Re: DEP #315-1227 Site Plan and RFA Narrative Revisions

Please accept the enclosed amended plans and revised RFA narrative supporting DEP #315-1227. The amended two plan sheets - Drainage Plan 1 of 5 and 2 of 5 – (sheets C.16 and C.17) now show that no work other than Stormwater Management will take place in the RFA Per 310 CMR 10.58 (4).

**PROPOSED MULTIFAMILY
 DEVELOPMENT
 SUMMER STREET
 WALPOLE, MA**

**GRADING AND DRAINAGE PLAN
 1 OF 5**

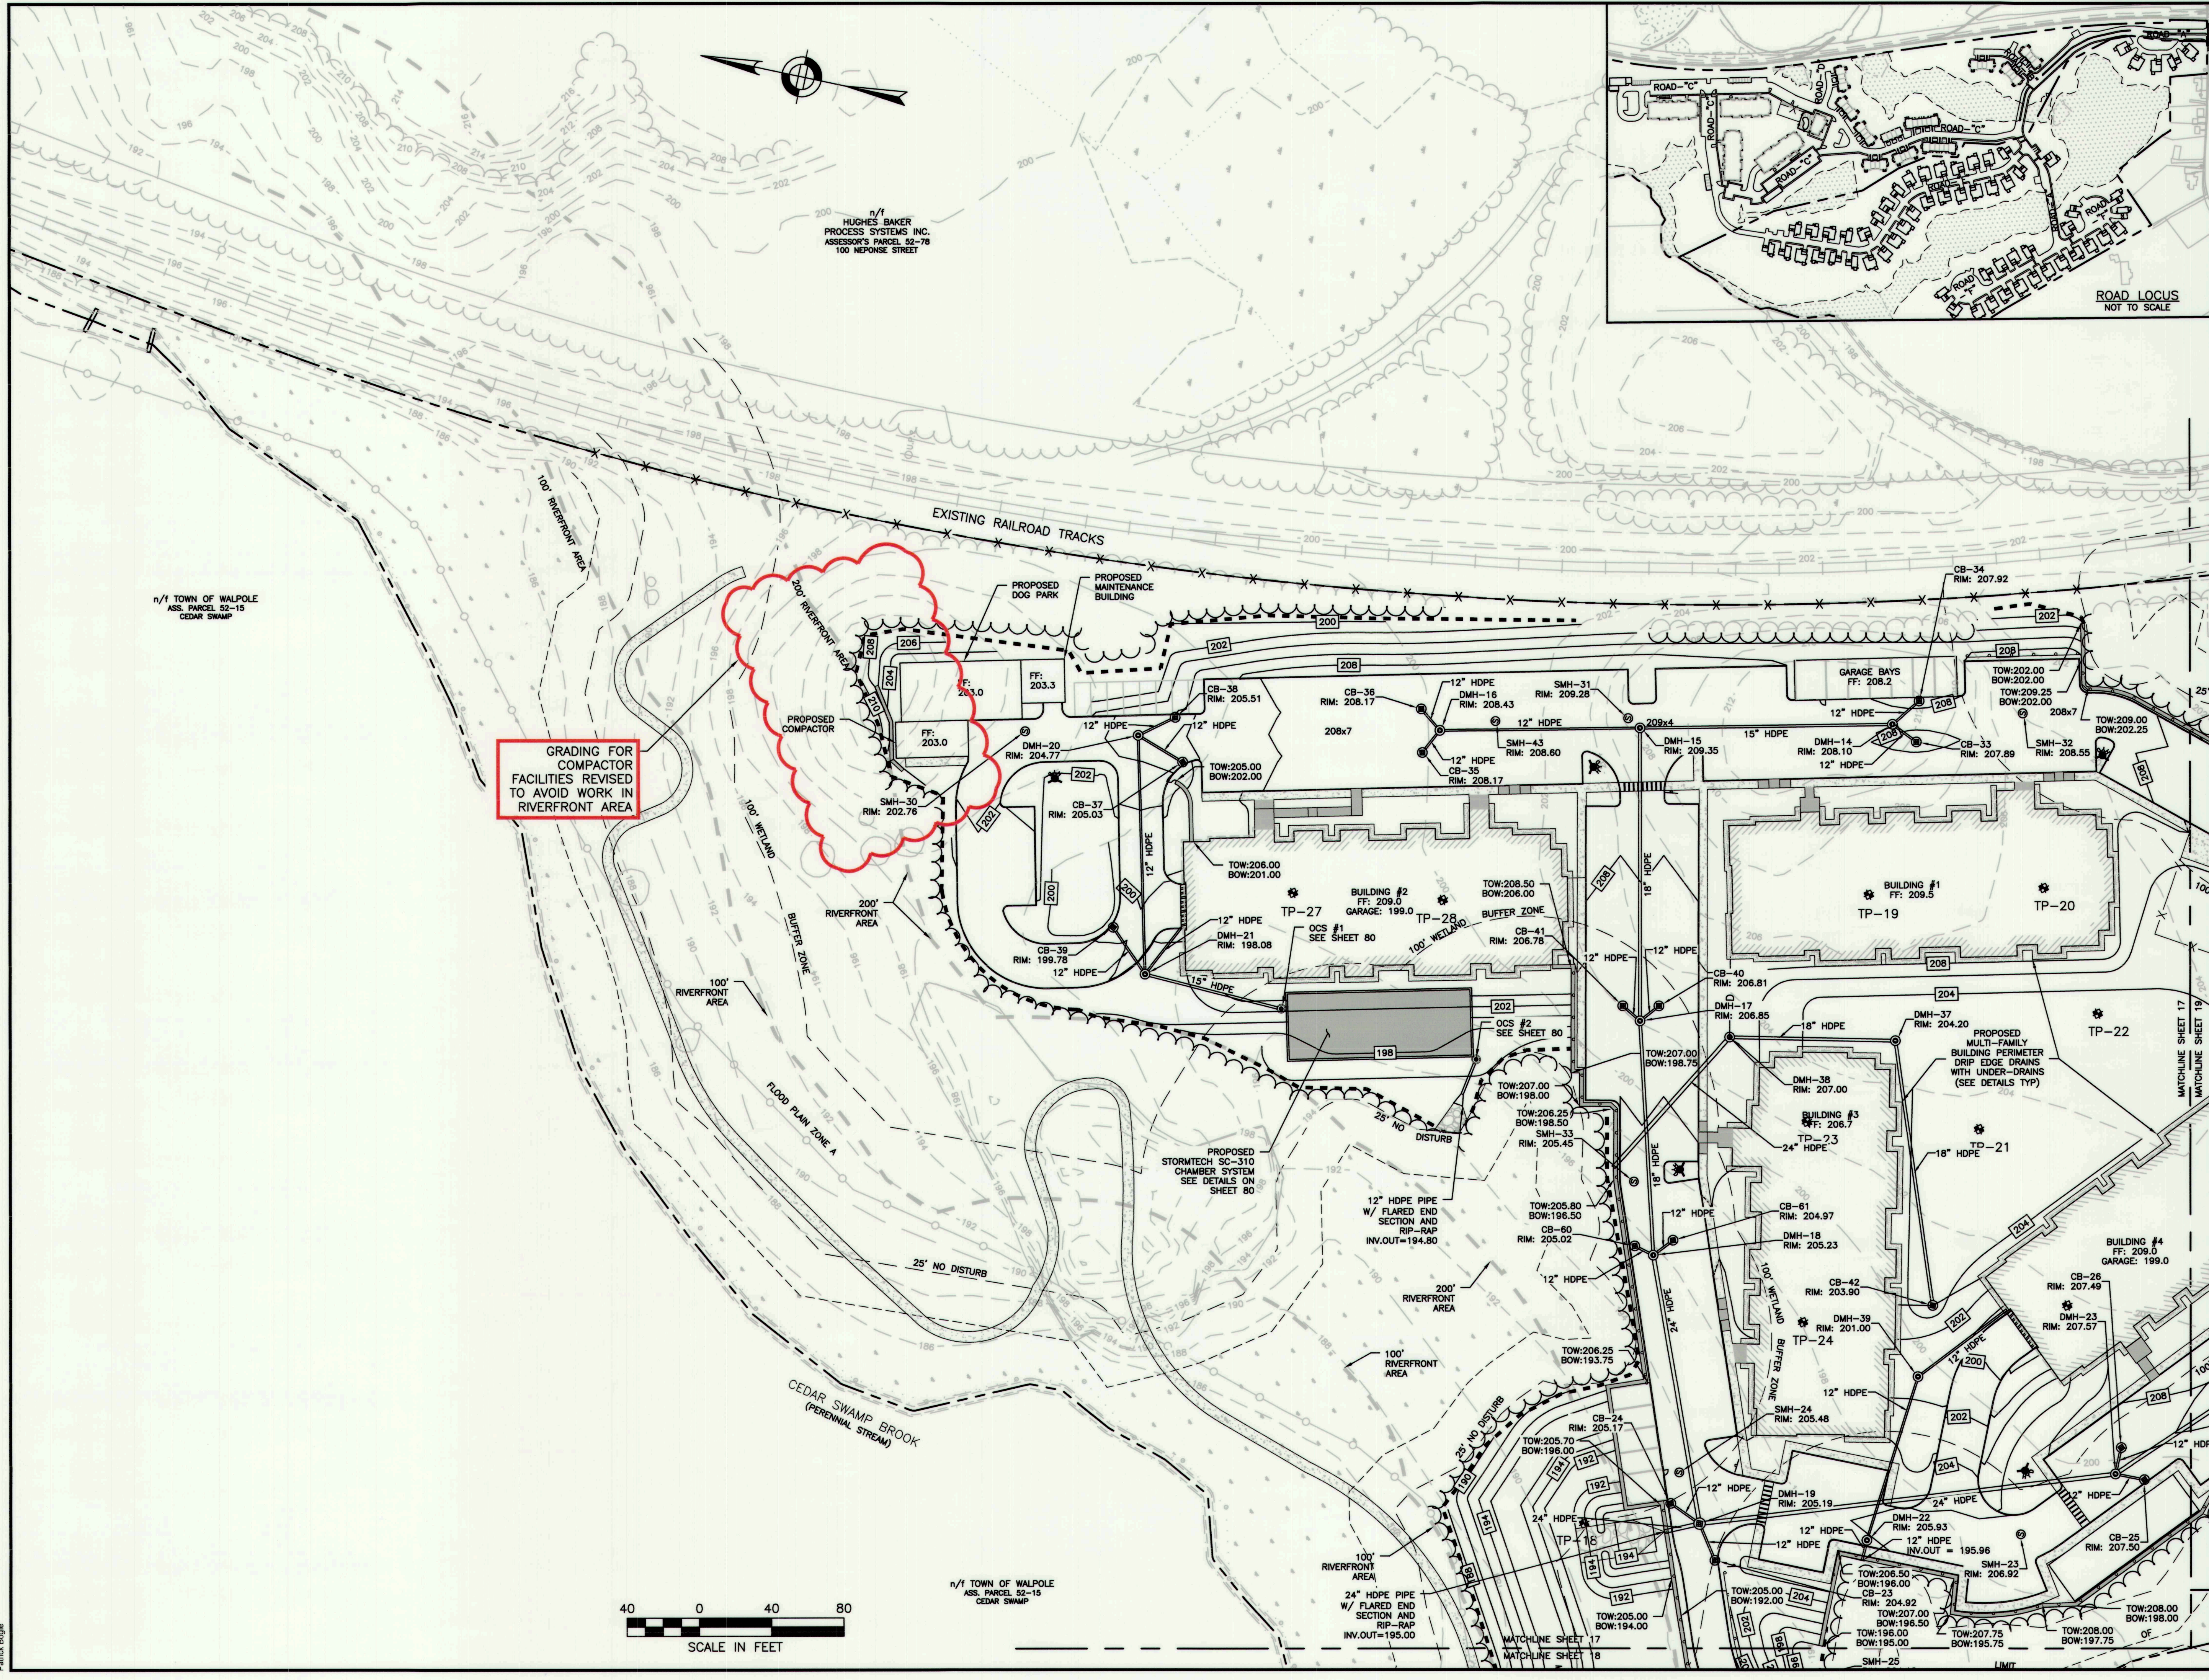
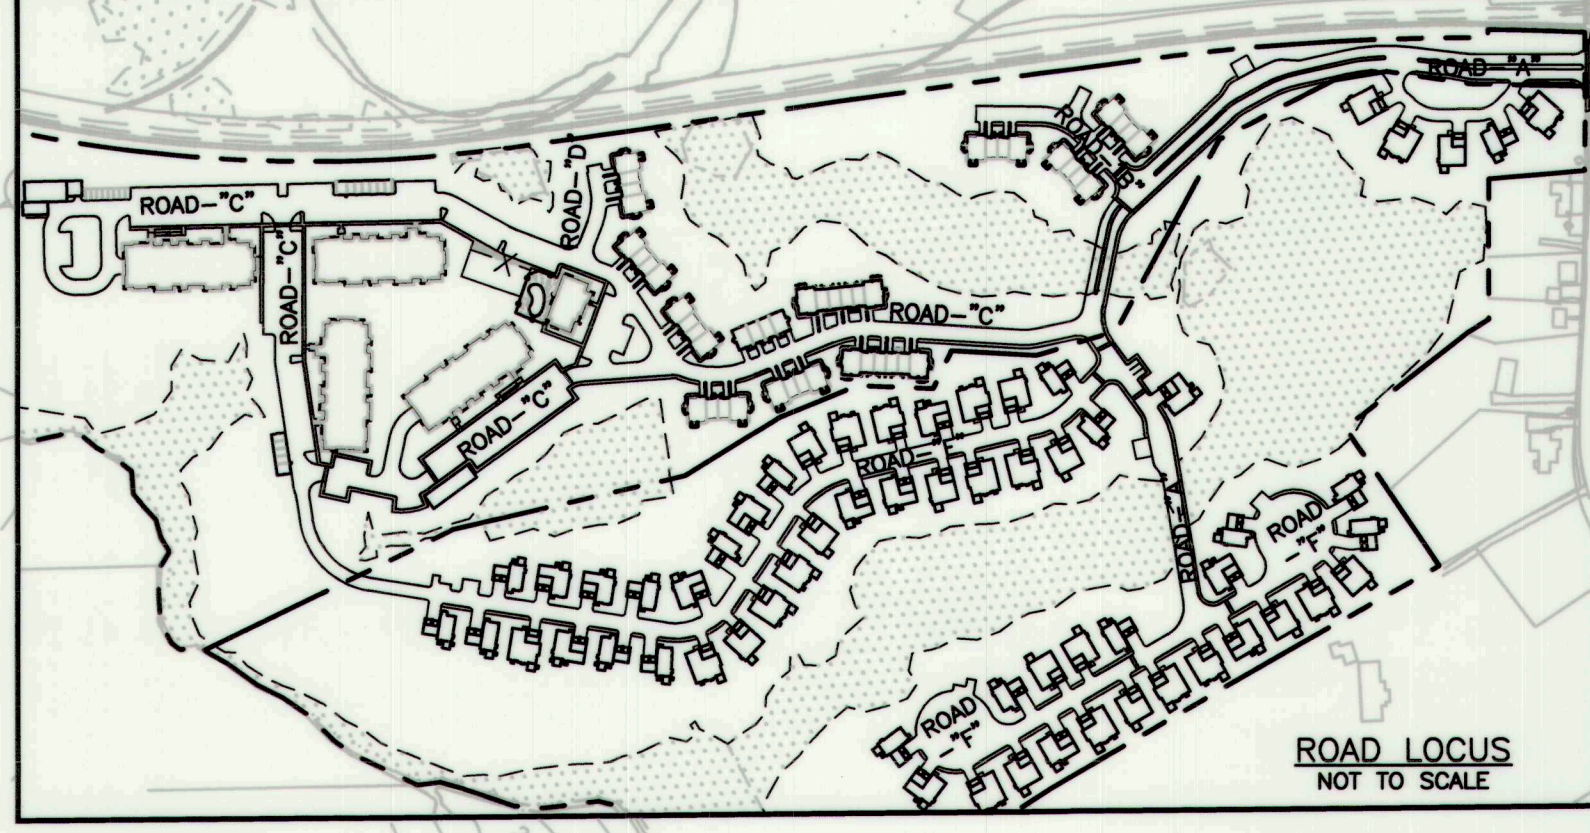
The previous submission of plans, dated May 1, 2020, showed roughly 4,000 sf of allowed disturbance within the riverfront area which was not associated with stormwater management. The revised grading shown on the amended plans, will eliminate any disturbance not associated with an exempt stormwater practice. The small section of grading located to the north of the dog park and compactor will see the installation of a retaining wall to reduce the grading and remain out of the 200' riparian zone. The previous disturbance to the west of single-family homes 22-28, has been regraded with larger reveals in the rear of the units and feature elevated decks.

GRADING FOR
 COMPACTOR
 FACILITIES REVISED
 TO AVOID WORK IN
 RIVERFRONT AREA
